TOWN OF MONUMENT - WATERLINE AND STORAGE TANK
 SITE DEVELOPMENT PLANS
 LOT 6, FOREST VIEW ESTATES FILING NO. 4

90% SUBMITTAL

Site Development Plan _V2 redline.pdf Markup Summary 1-27-2022

PROJECT LOCATION MAP

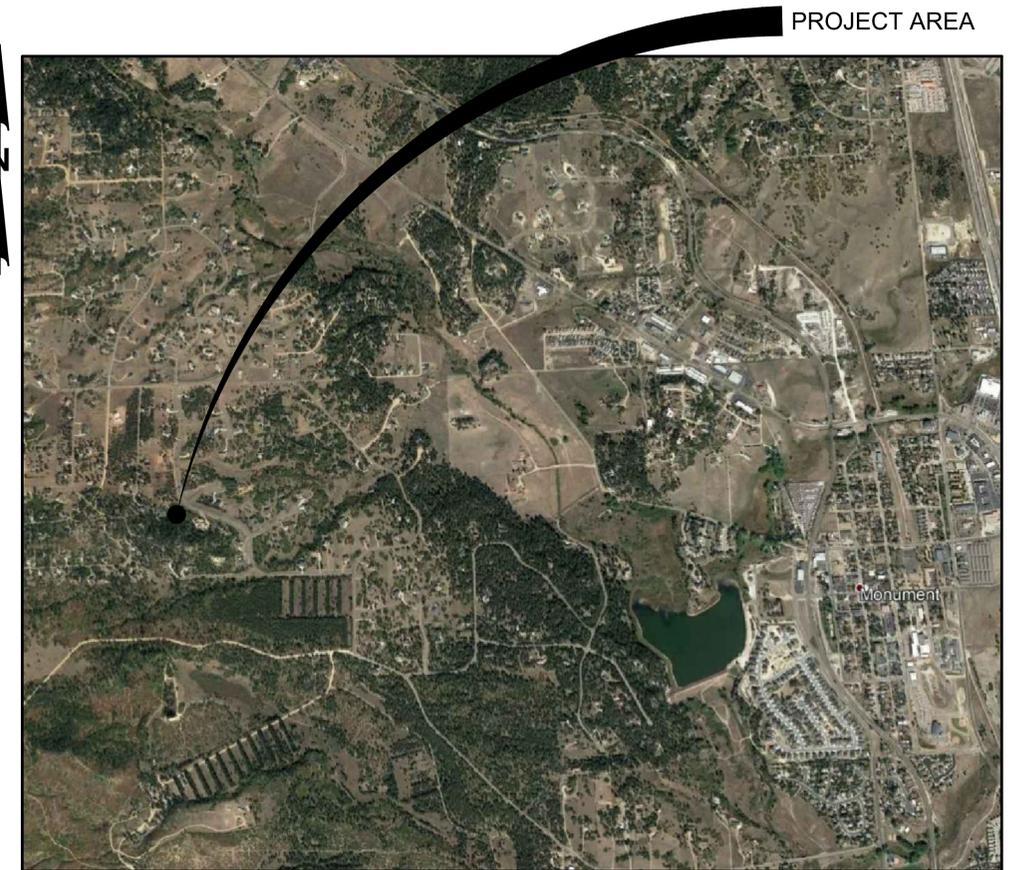
Please remove these signature blocks from the site development plan. The engineering manager does not approve construction drawings (line CDs) under a site development plan. You can label construction plans in this document as "reference only" since the construction drawings will be reviewed for approval.

delete this... this a submittal for approval... Add the file number to the plans in lower corner; PCD file PPR 21 30

2.0M GALLON TANK SITE PLAN

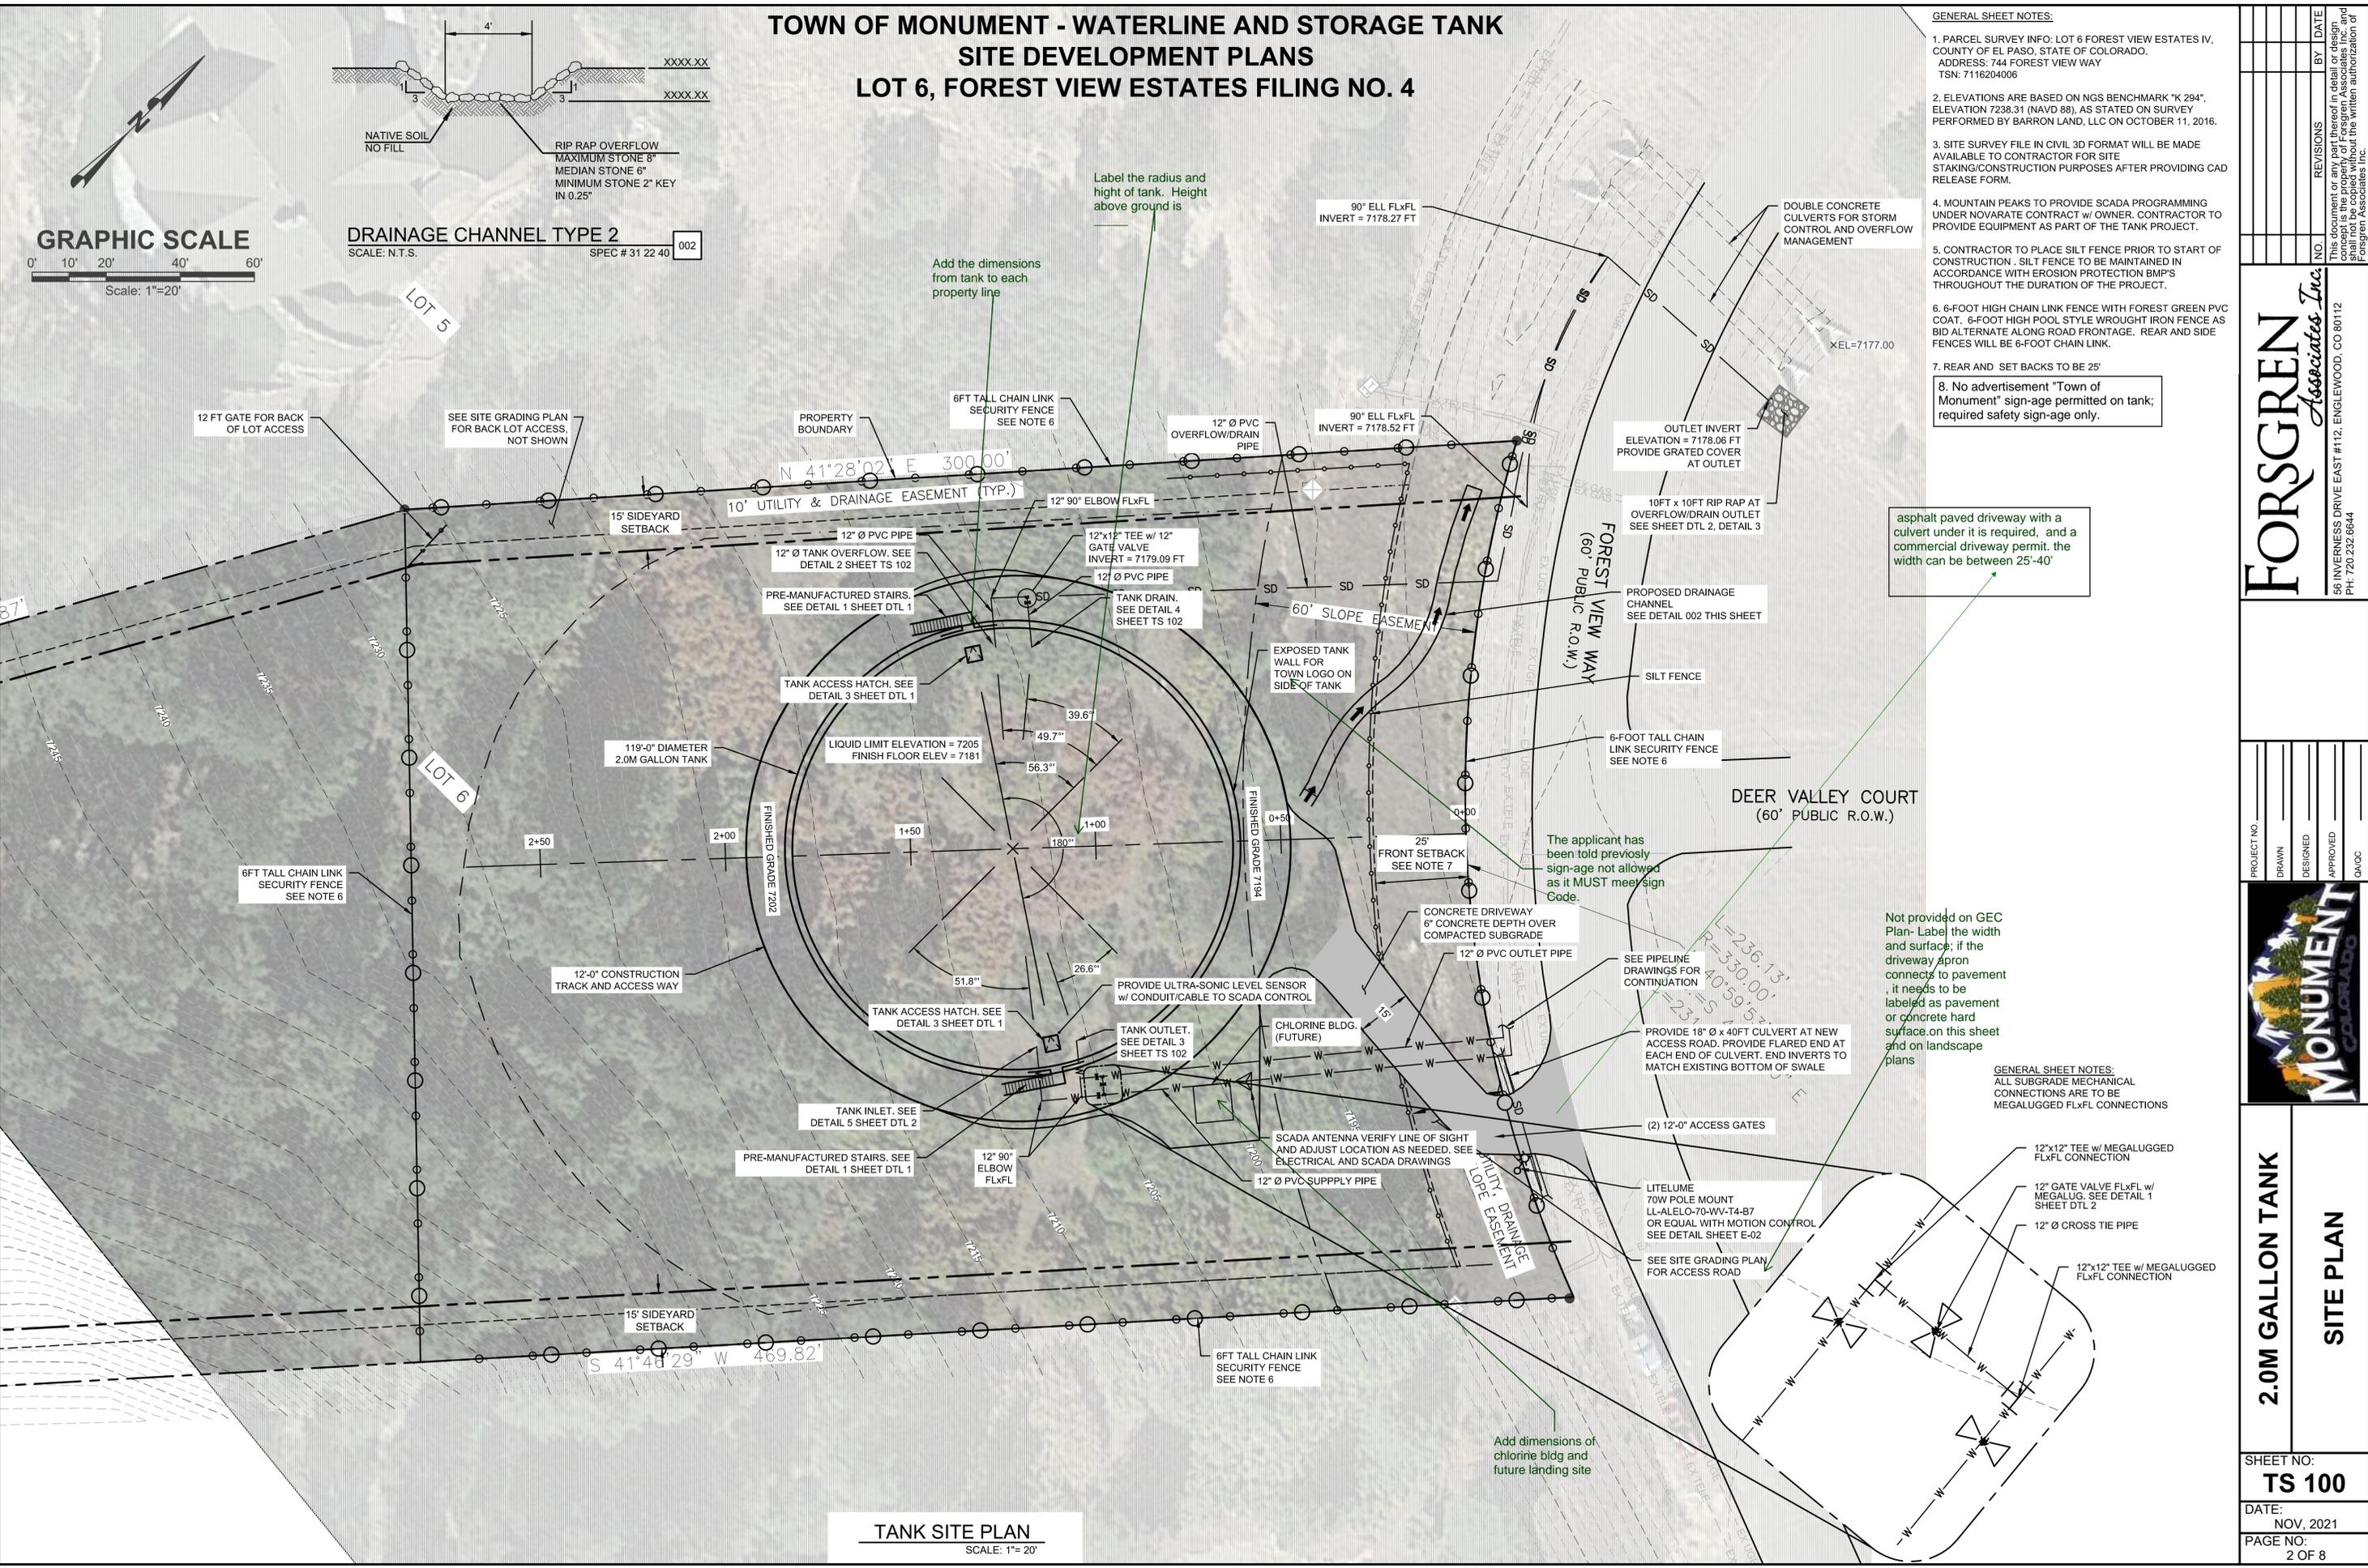
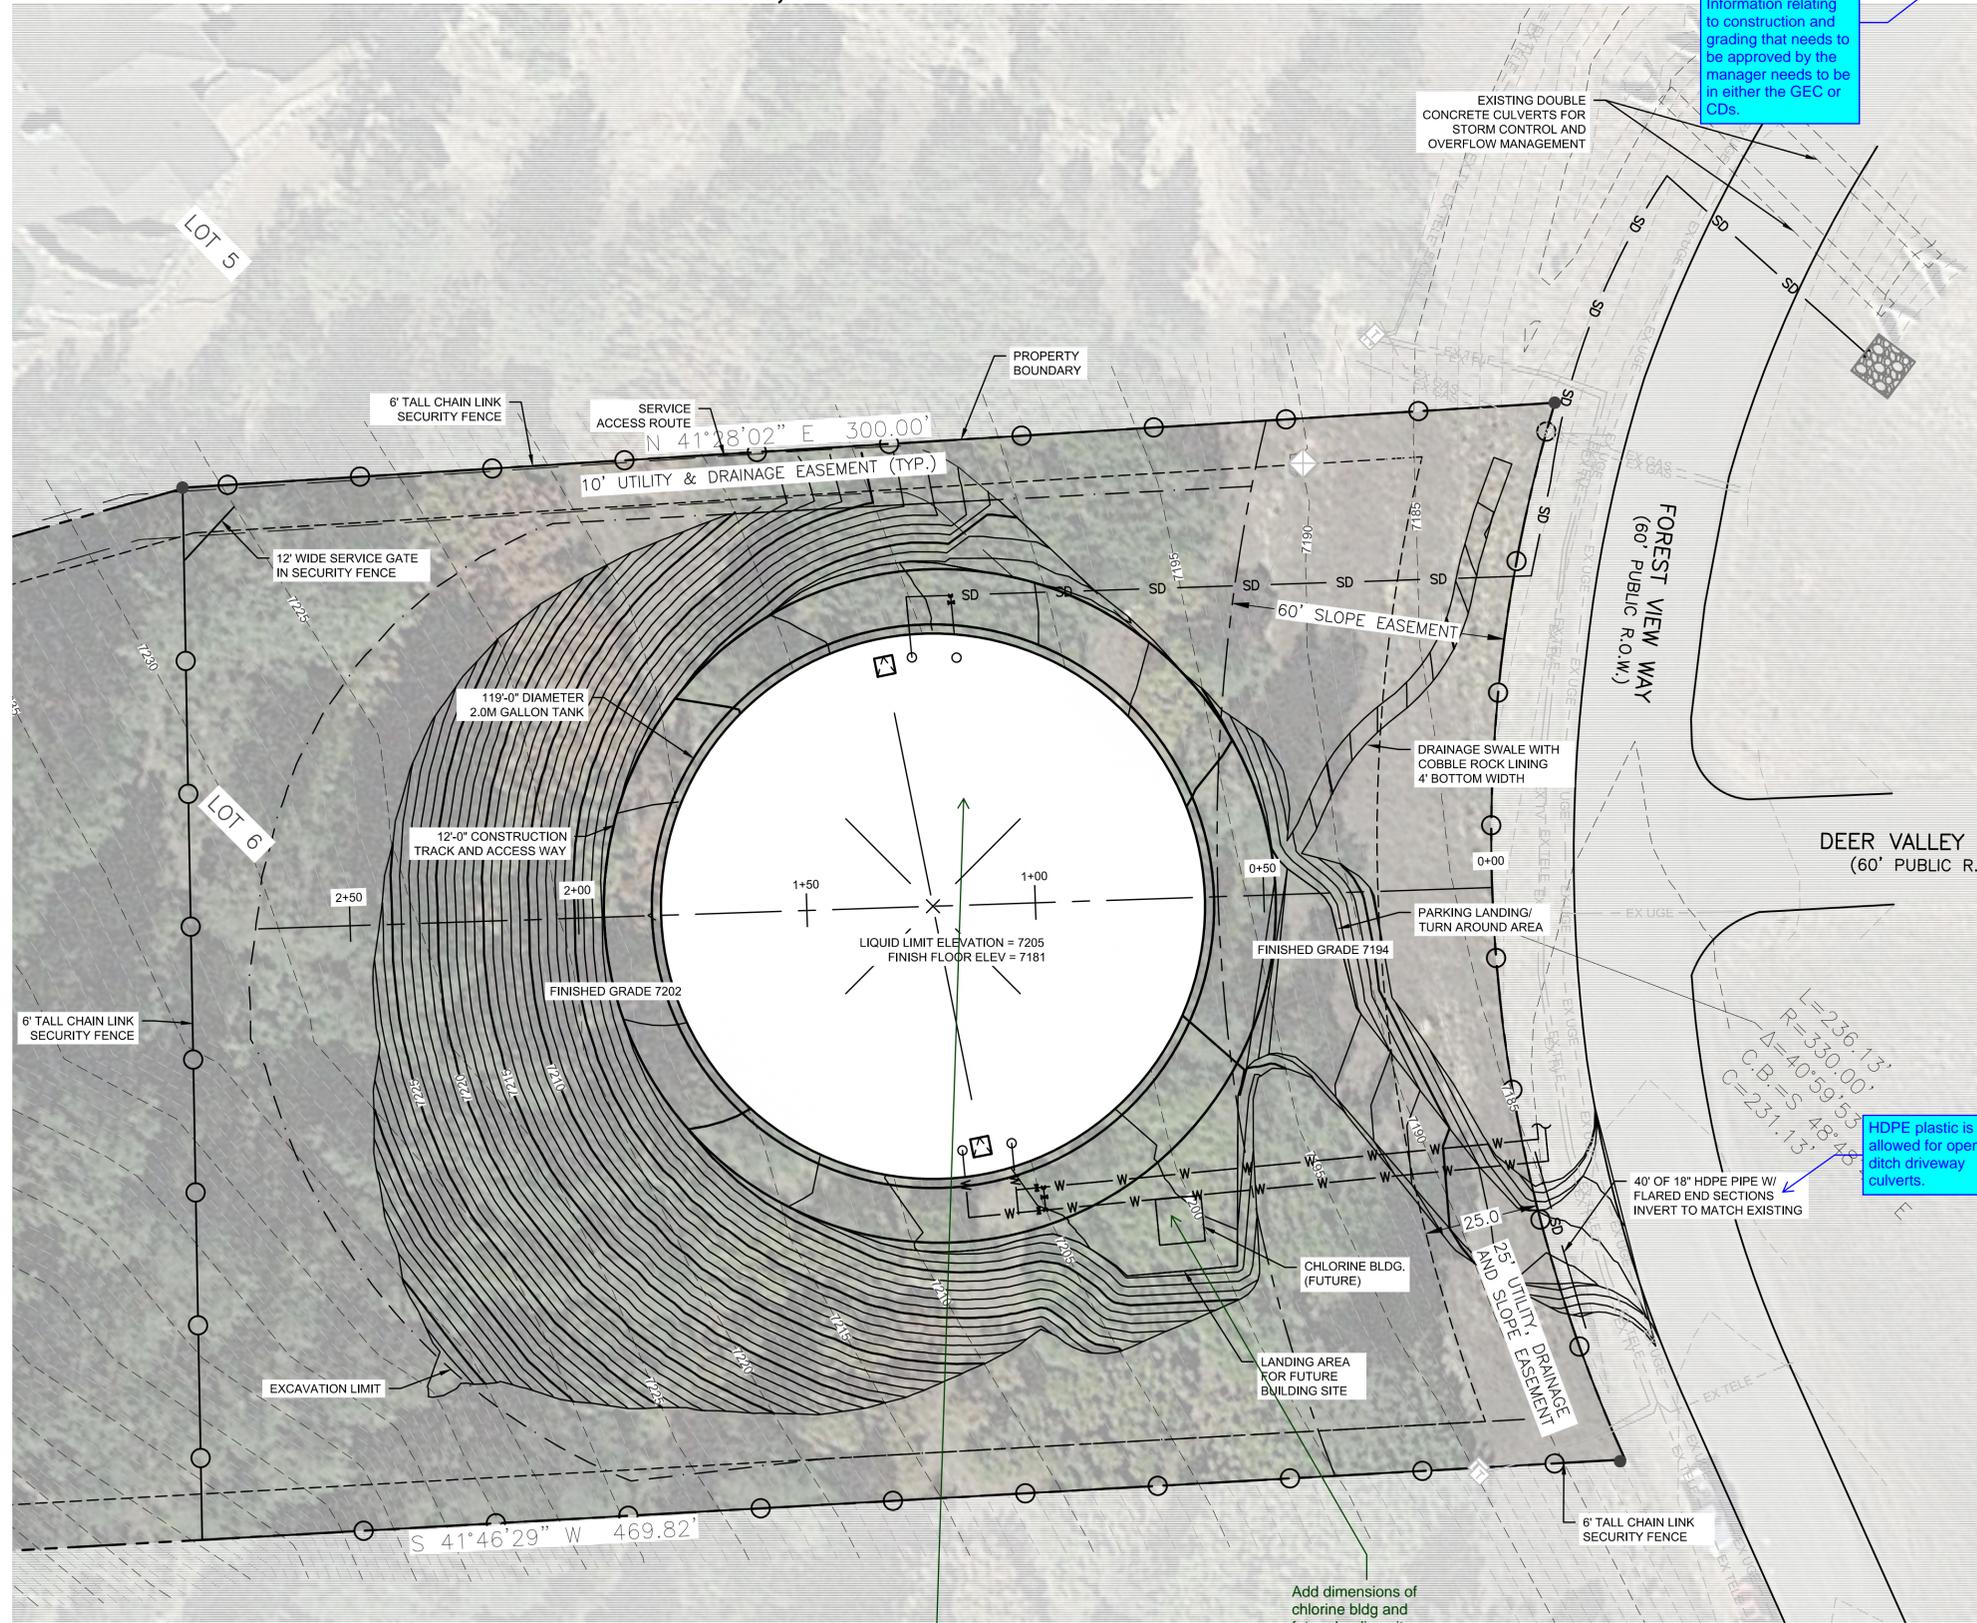
Please copy these grading notes to the grading and erosion control plan. FYI: Information relating to construction and grading that needs to be approved by the manager needs to be in either the GEC or CDs.

Provide the detail of the chain link fencing, and the alternative fencing.

**2.0M GALLON TANK
SITE GRADING PLAN**

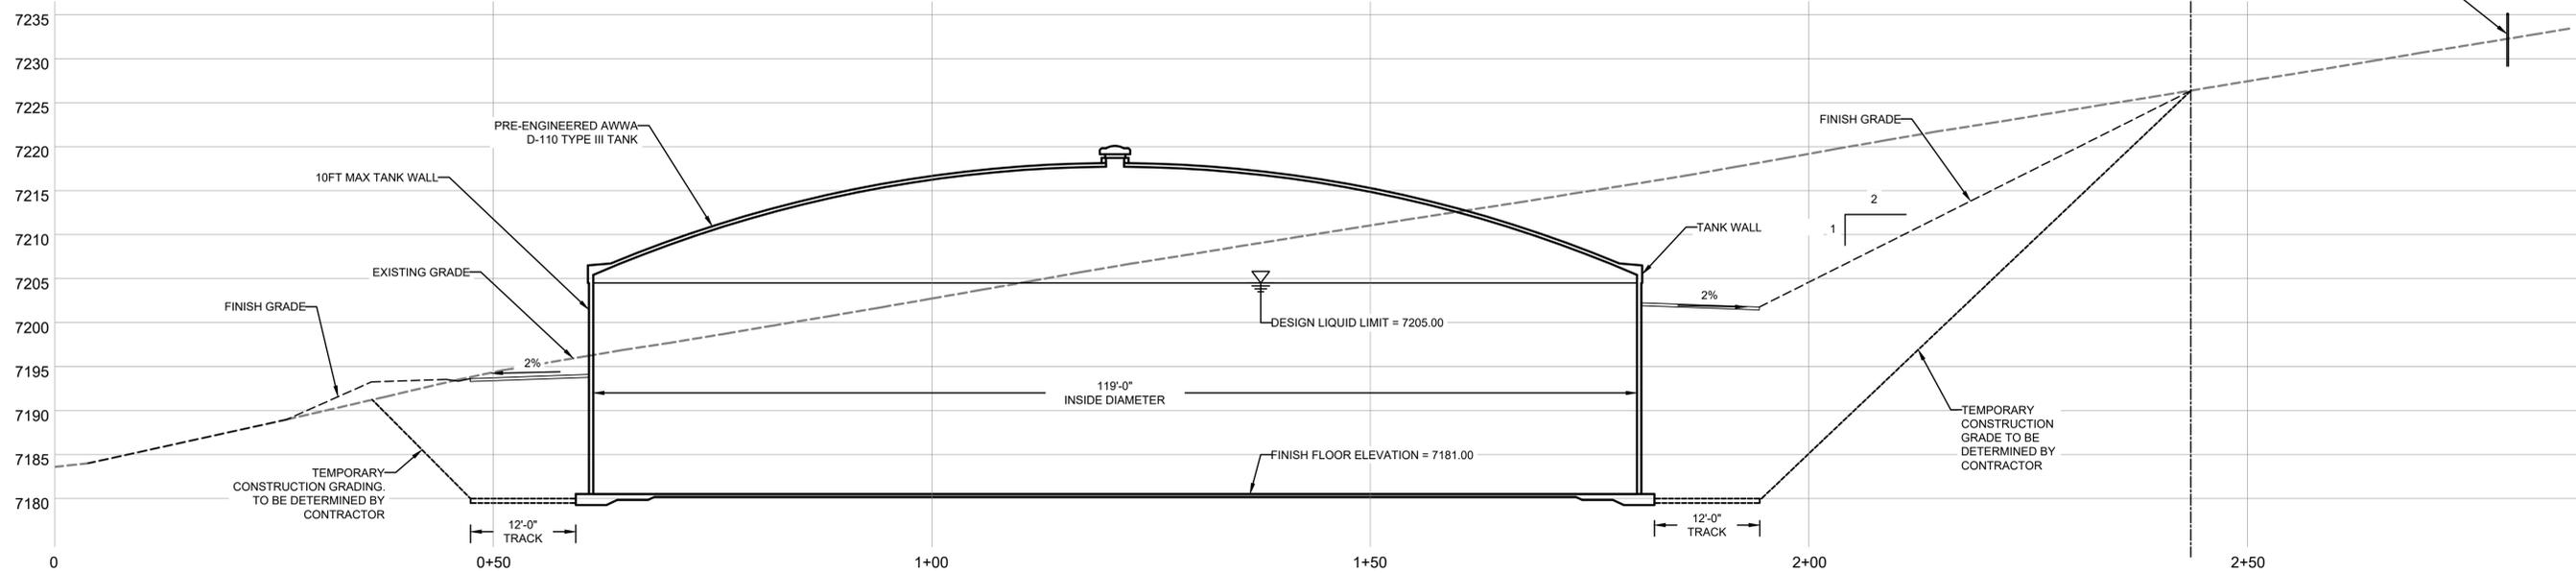
delete this from all pages- this is for a construction approval

HDPE plastic is not allowed for open ditch driveway culverts.

Add circumference and total gallon storage
